# US 97 BAKER RD INTERCHANGE AREA MANAGEMENT PLAN (IAMP)

JOINT TECHNICAL AND COMMUNITY ADVISORY  
COMMITTEE MEETING #4

JANUARY 10, 2022

## Alt. 1: Enhanced Existing Ramp Terminals

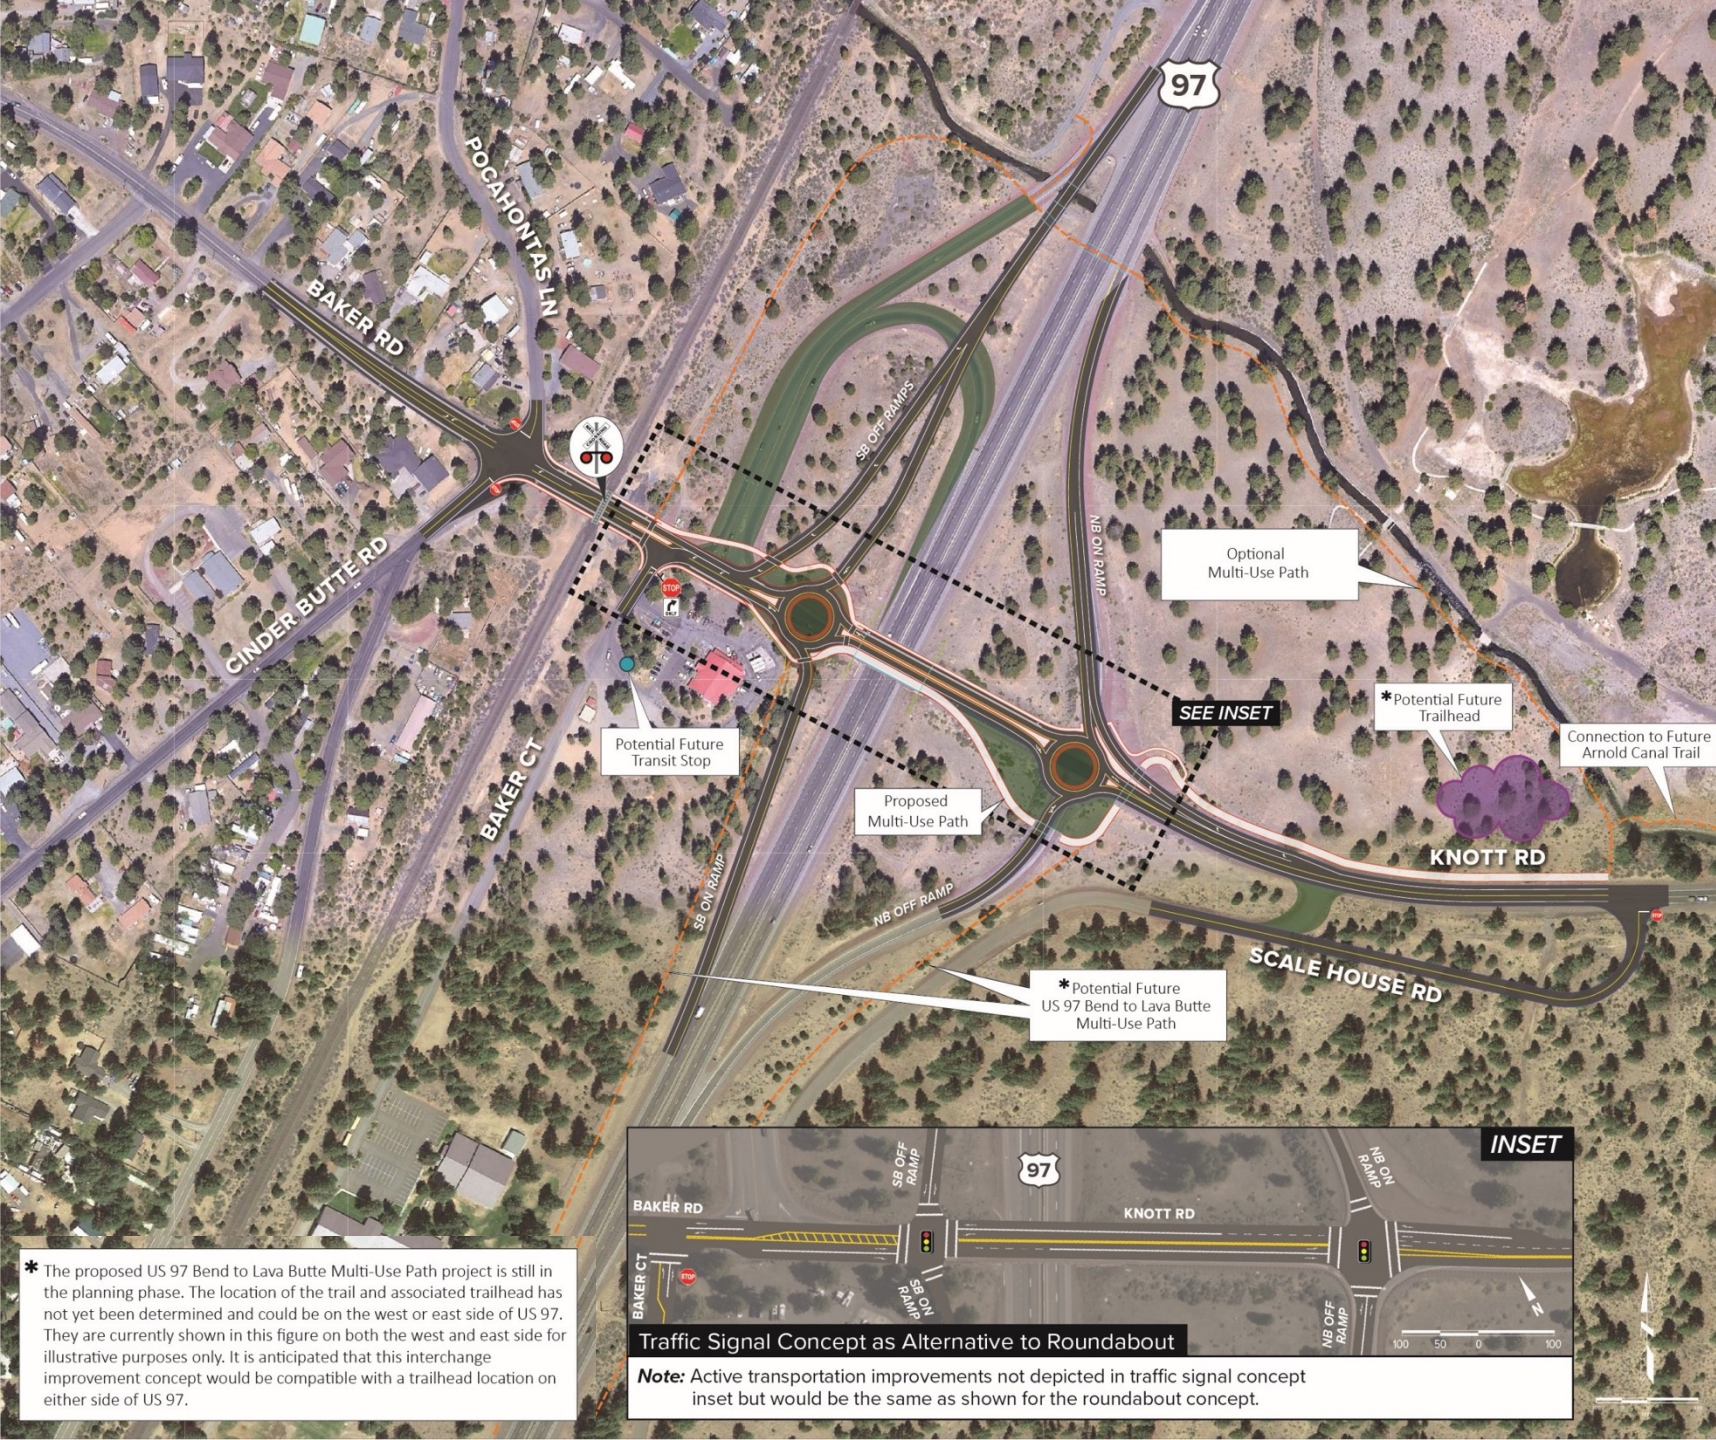
- A lot of interest in how improvements could be constructed in phases
- Alternative 1 brings the ramp terminal close to the railroad but also resolves access conflicts
- Alternative 2 has a less desirable at-grade crossing with the multi-use path on the south side
- Alternative 2 does not fully address access conflicts on the west side
- Alternative 3 cost is high, and the complex construction risks may increase the cost further
- Alternative 3 may be more difficult to build in phases

- > Preference for Alternative 3, but recognize cost is high. Second choice is Alternative 1 (2 votes) or Alternative 2 (1 vote). Some concern with Alternative 2 was expressed due to the multi-use path crossing. Some concern with Alternative 1 was expressed because it includes a traffic signal.

## Alt. 2: Tight Urban Diamond Interchange (TUDI)

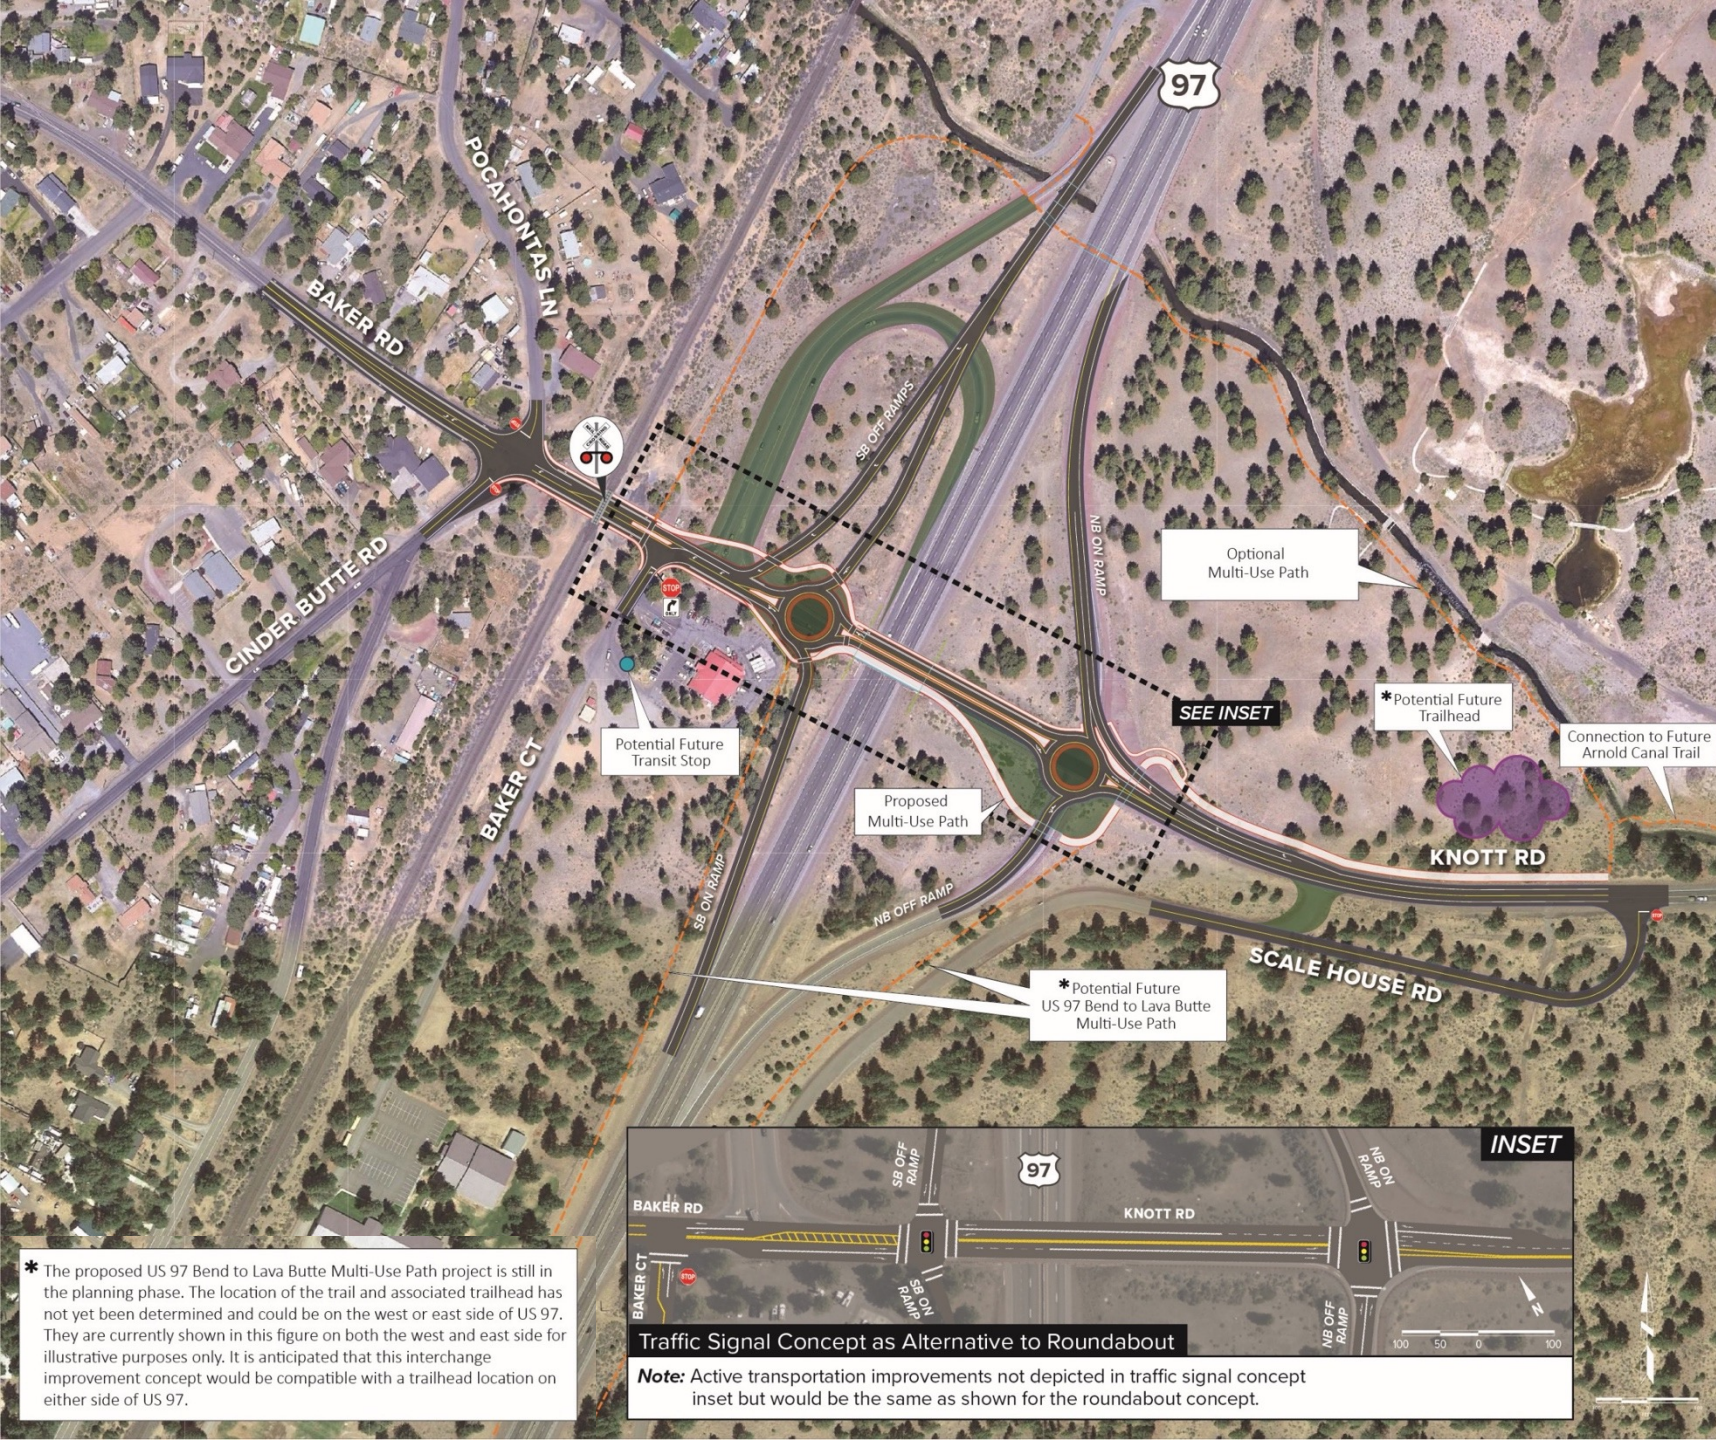
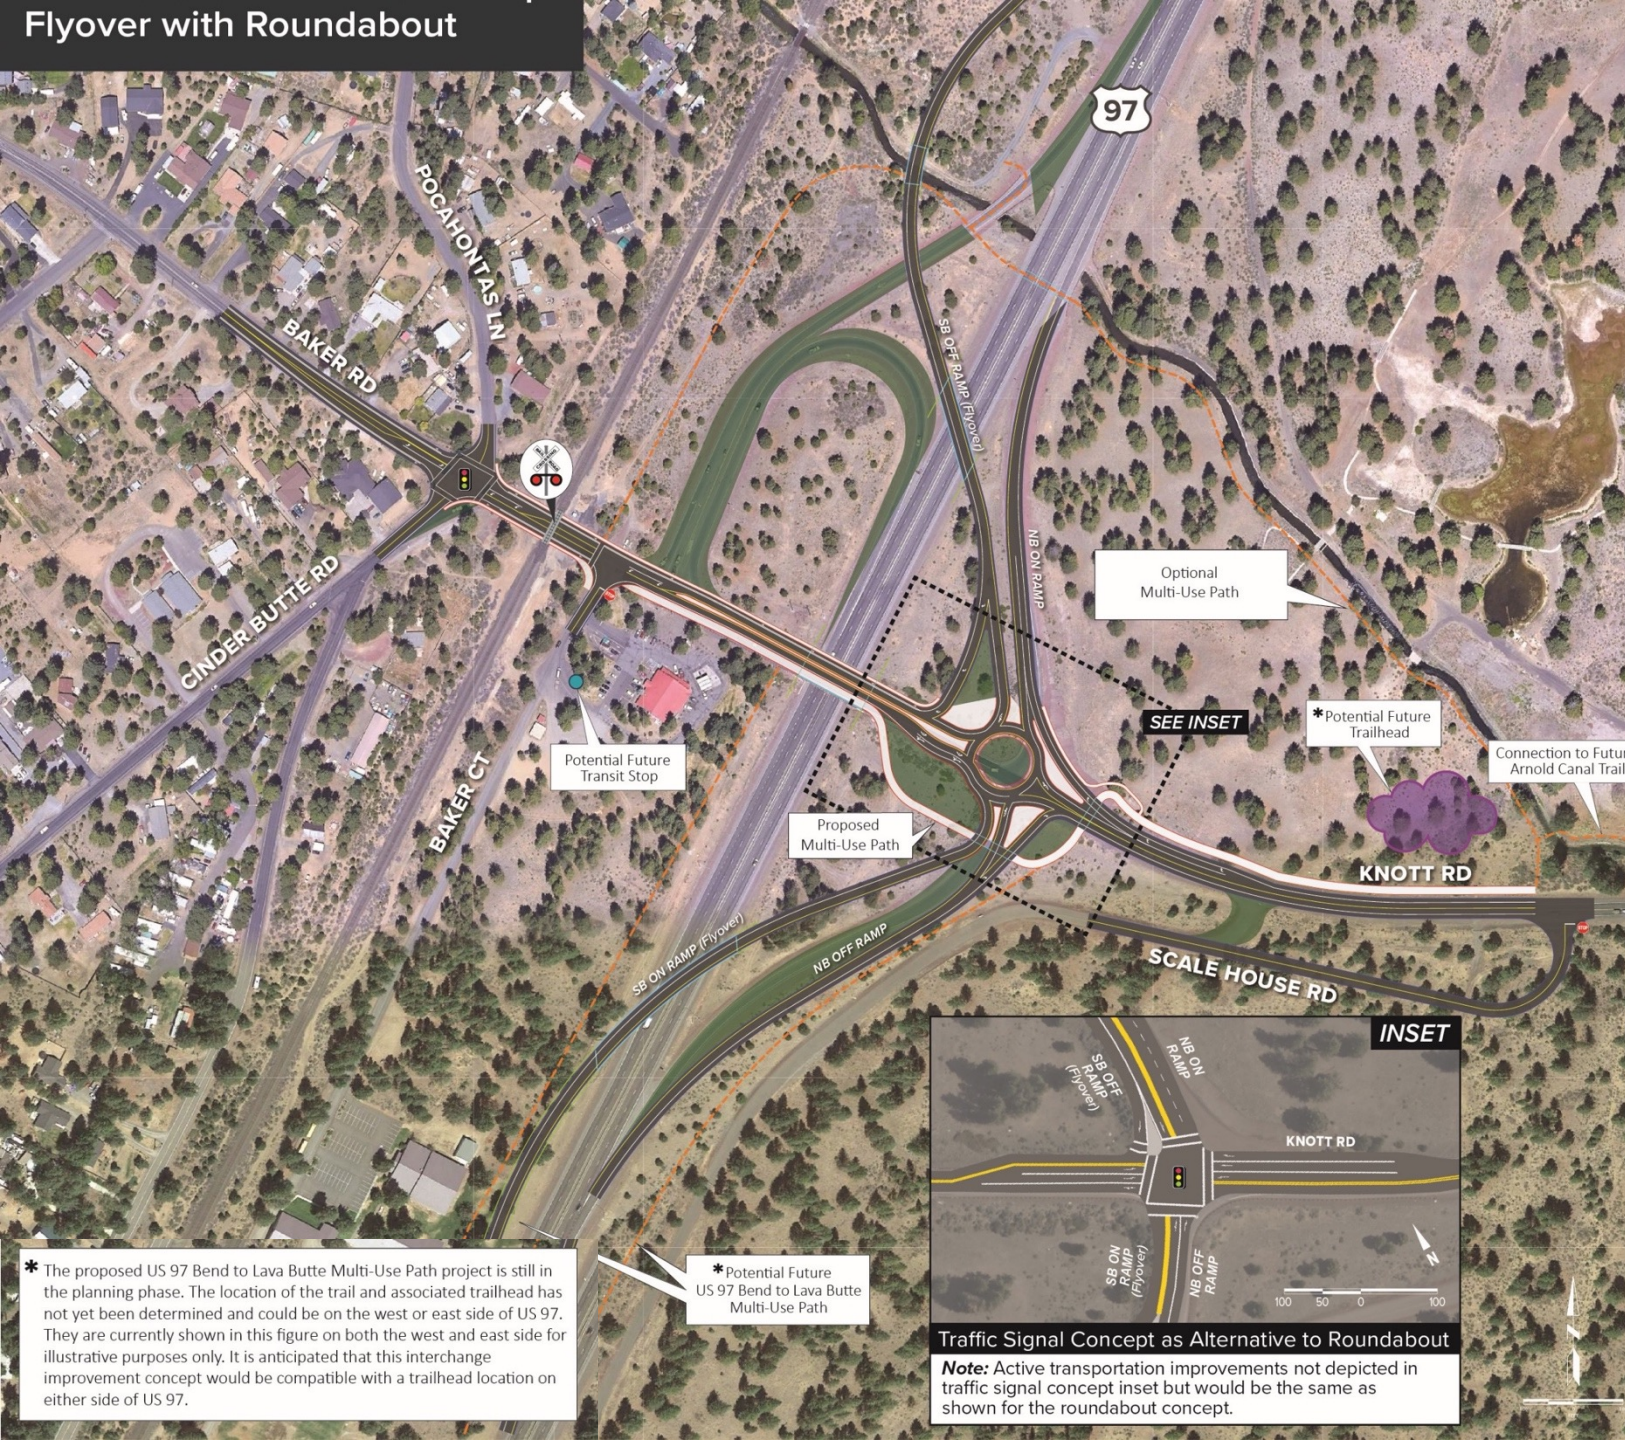
- Alternative 2 is the only alternative to include an at-grade vehicular crossing with the low-stress multi-use path. This is NOT considered to be a fatal flaw, but is not desirable.
- Alternative 3 creates opportunity for access to properties in the NW quadrant.
- Alternative 1 rates the lowest for evacuation support.
- Alternative 2 would be more impacted by railroad crossings than other alternatives
- Our recommendations would be to use RABs (not SB Alt 1) unless found to be not feasible per freight discussion
